Subject: Class 1* Permit Modification Notification to the Waste Isolation Pilot Plant Hazardous
Waste Facility Permit Number: NM4890139088-TSDF

- Changes to Groundwater Sampling Procedures

Class 1* Permit Modification Notification
Changes to Groundwater Sampling Procedures
Waste Isolation Pilot Plant
Carlsbad, New Mexico
WIPP Permit Number - NM4890139088-TSDF

Figure 1. H-19 Well Pad Configuration

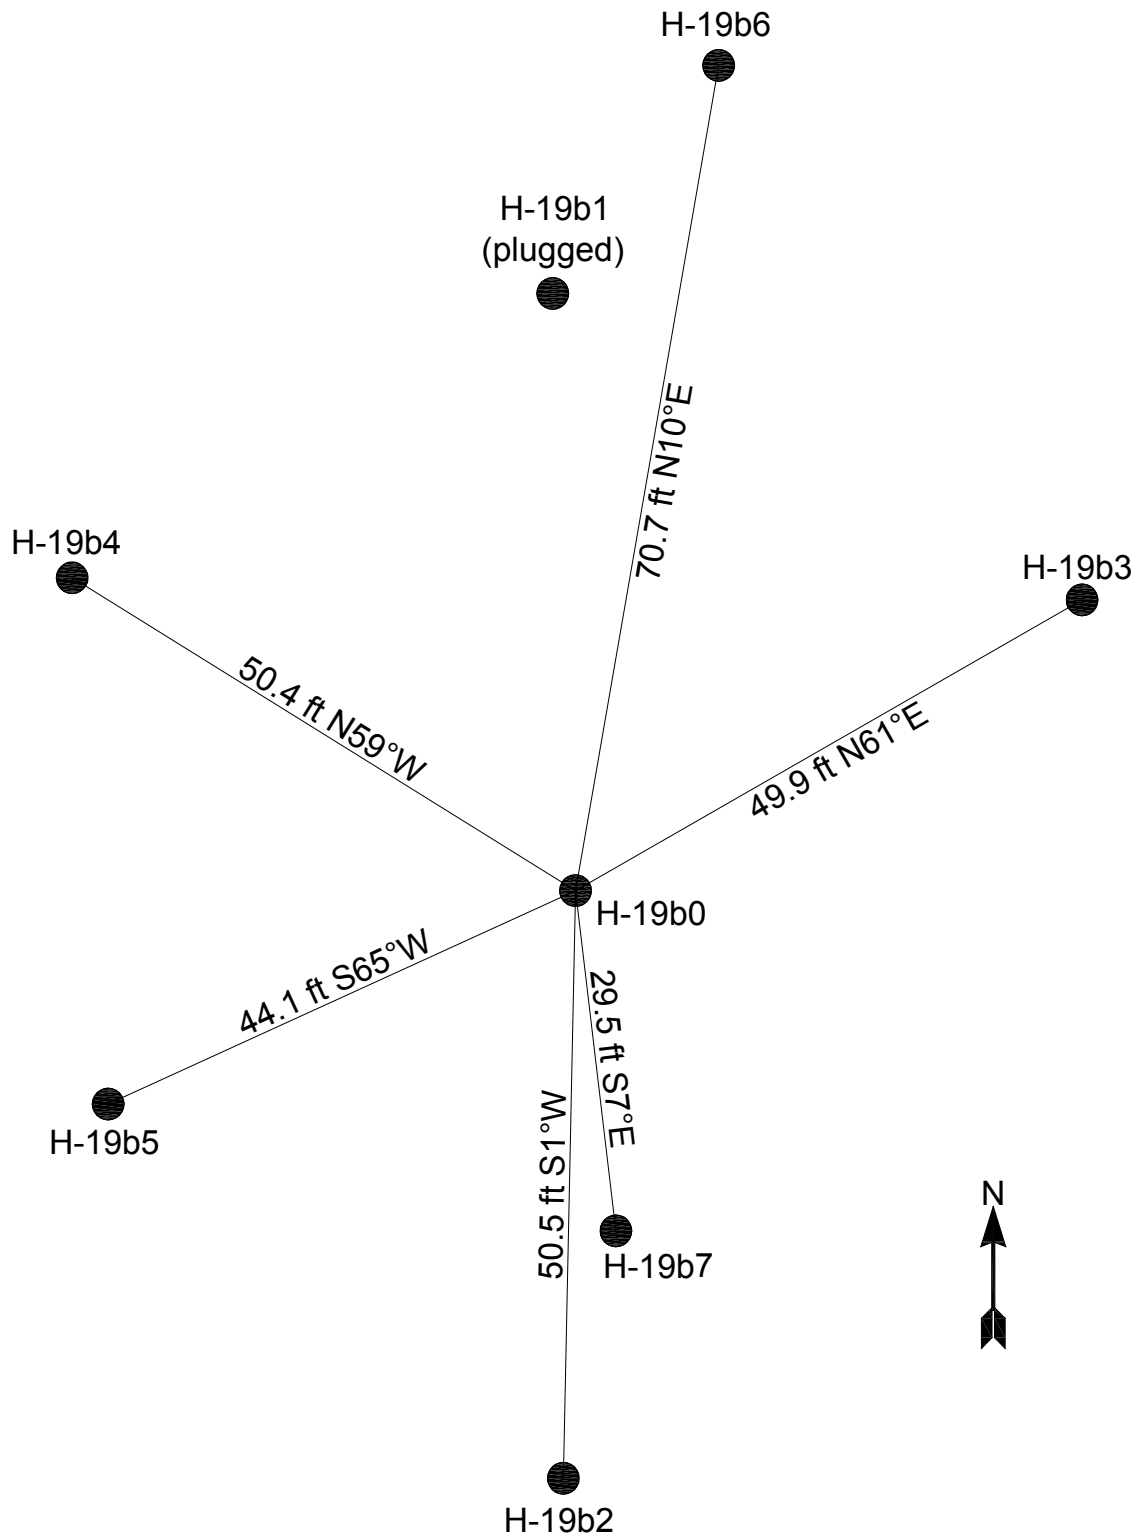
The Permittees are proposing to use the data from the in-situ pressure transducer at well H-19b0 to obtain an annual fluid density measurement that is functionally equivalent to the fluid density at the other wells on the H-19 pad and discontinue the manual downhole measurements. The rationale for making this change is as follows. The wells on the H-19 pad lie within a 71-foot radius of the H-19b0 well (see Figures 1 and 2). Data have shown that differences in the groundwater densities of the H-19 wells are negligible (see Table 1 below); therefore, using the data from the in-situ pressure transducer at the H-19b0 well is functionally equivalent to the data from individual measurements obtained from the H-19b2, H-19b3, H-19b4, H-19b5, H-19b6, and H-19b7 wells. The groundwater density measurements taken at well H-19b0 may be used to correct for freshwater head for Culebra groundwater wells H-19b2, H-19b3, H-19b4, H-19b5, H-19b6, and H-19b7. This change is needed to provide efficiencies in the Detection Monitoring Program (**DMP**) since the continuous in-situ pressure transducer measurements at well H-19b0 will replace the annual manual measurements at the other wells on the H-19 pad. This will allow the Permittees to discontinue the use of trailer-mounted measuring equipment and procedure WP 02-EM1021.
